Ensuring safe access to wildlife in Lumding Reserve Forest, Assam, India

Mitigating the impacts of up-gradation of Doboka-Silchar
National Highway (NH54E)

B. COMMENTS ON THE PROPOSED MIGRATION ACROSS THE PROPOSED HIGHWAY

Figure 2: Schematic diagram showing arrangement to accommodate 6m high elephant passage in areas with limited land availability

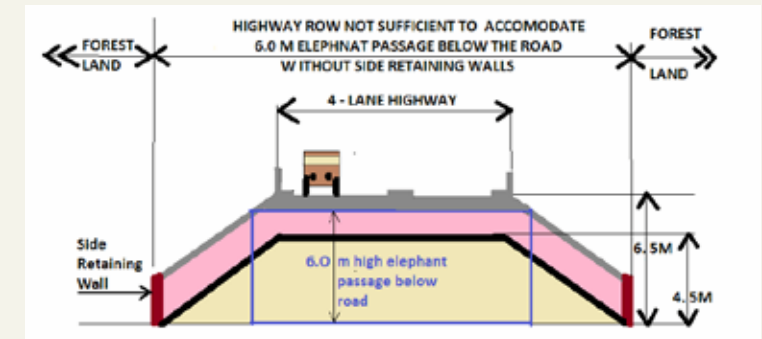
(5) It was informed by the National Highways Authority of India (NHAI) officers that the land width at km35.8 is not sufficient to raise the height of passage from 4.5m to 6m, as the side slopes of the embankment will encroach upon the forest land. It is advised that this location should be retained at its present state for the safe passage of elephants, as the surrounding landscape strongly advocates for elephants' passage at this location. Presently they are crossing through the road. To overcome the land constraint, a retaining wall of suitable height can be constructed at the land

boundary to allow raising of the adjoining embankment for 6m high passage (Figure 2).

Figure 3: Isometric view of the natural passage over the underground road in the forest

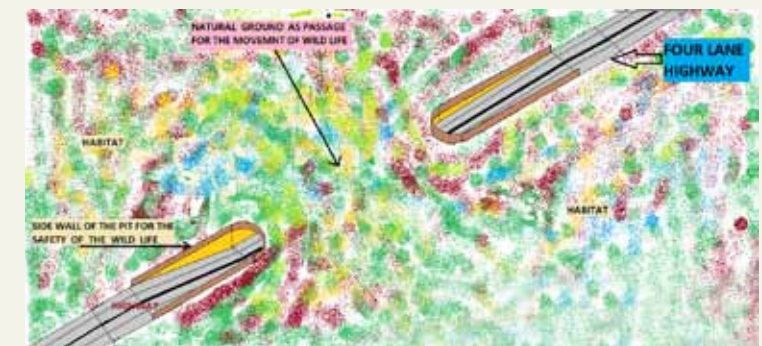
(6) In a 24.613km long stretch of forest, passages with less than 5km spacing are desirable for maintaining the connectivity of the habitat. Therefore, one more suitable passage is required between km35.8 to km44.379 (8.579km) which is likely to help maintain better connectivity. The best passage for animal movement, particularly the elephants, is the natural terrain. In this section the road near km40.4 can be accommodated in a tunnel section (cut and cover) in suitable length, leaving the elephants' movement unaffected through the adjoining natural ground. The location of the passage is selected in such a way that the water collected in the underground portion of the passage is drained to lower areas through pipes laid laterally, as the terrain is hilly. The details are shown in Figure 3 .

Figure 5 – Diagram of isolated and wall type piers in underpass

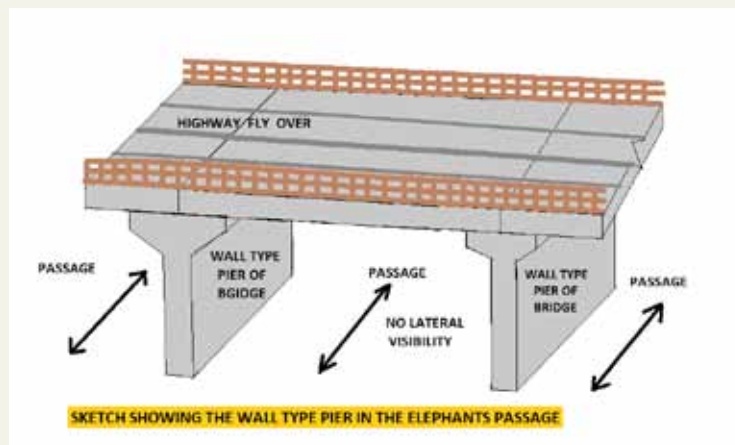
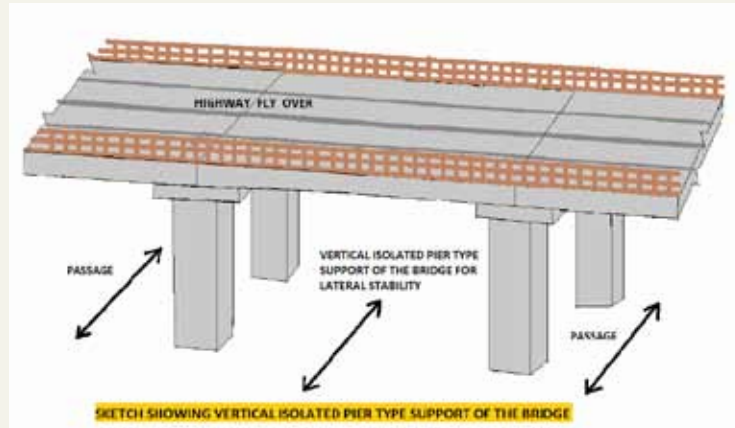
It is indicated by the NHAI officials that the underpass bridges will be supported on the RCC wall type piers. The wall type piers will create problem of lateral visibility of the crossing elephant herd. It is suggested that isolated end piers with cross beam at the top should be provided instead of wall type piers (Figure 5). This will provide better lateral visibility and movement to the crossing herd below the bridge. It is also informed by the NHAI officials that in place of the median between the left and right halves of the deck slab, about 1m wide opening shall be provided along the full length of the bridge. This should be avoided to minimize the noise disturbance level for the elephants using the passage, as the opening will give way to disturbing sound propagation.

An elephant underpass has been constructed across the highway adjoining the Manas National Park in Assam, a photo of which is shown in Figure 6. The central pier in this underpass can be modified as depicted in Figure 7 to facilitate lateral visibility for the benefit of passing elephant herds.

Figure 9 – Barrels of *Duggada* drainage crossing on the *Chilla* Hydro Power Canal in *Rajaji* National Park, *Uttarakhand*

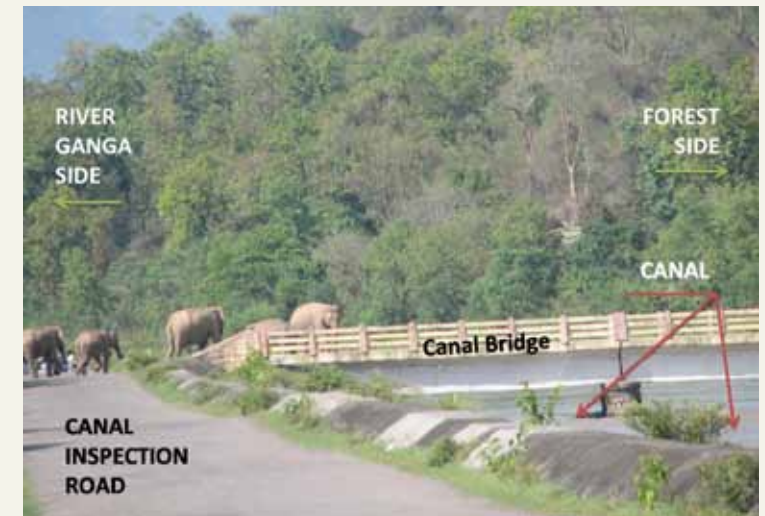
On the power canal of the *Chilla*-Hydro Electric Project in the *Rajaji* National Park in the state of *Uttarakhand*, several structures like small bridges, barrels below the canal and super passages are made over the canal. The herds preferred using the narrow road bridge (Figure 8) over long barrels of *Duggada* drainage crossing (Figure 9).

Figure 11 - View of the underpass with side space from a different location

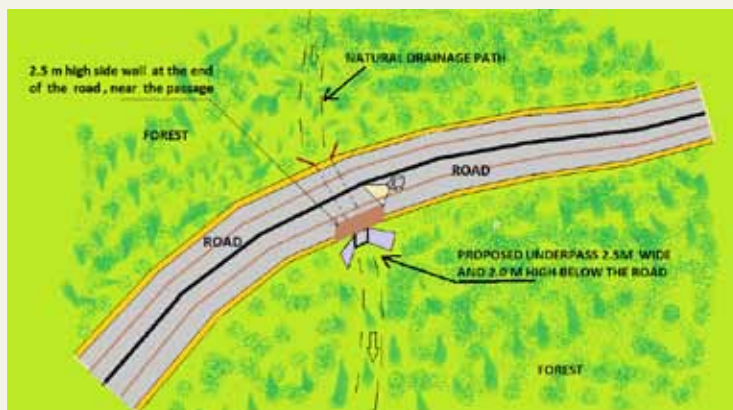
(2) In the entire patch of the forest the NHAI has provided pipe culverts, box culverts, slab culverts and big bridges on the natural drainages across the highway. They have provided different sized openings in the structures. The proposed small slab/box culverts with minimum opening size of 2.5m width and 2m height can well be used as the crossing passages by wild animals other than elephants (Figure 10). In the passage where there is continuous running of water, some side space should be made for the reptiles and amphibians (Figure 11).

Figure 13 - Isometric view of the monkey passage over the proposed highway

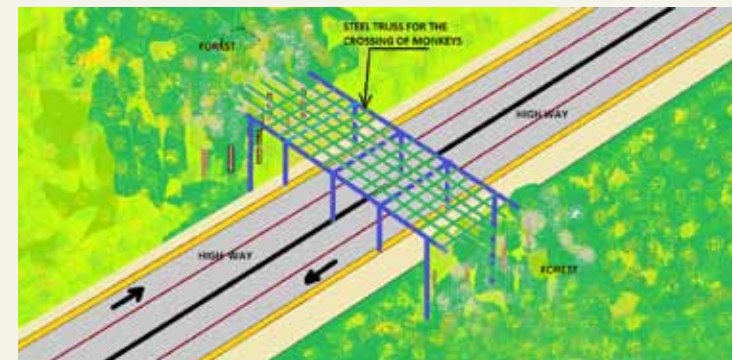
(1) A canopy type steel structure with sufficient head-room (5.5m approximately) for the road traffic may be provided for the connectivity for arboreal mammals in the habitat across the road. The canopy type steel structure will have to be connected to the trees of both sides. It is most likely that the arboreal mammals will use the canopy. The arrangement is shown in Figure 13. These canopy type steel structures should be covered with natural vegetation.
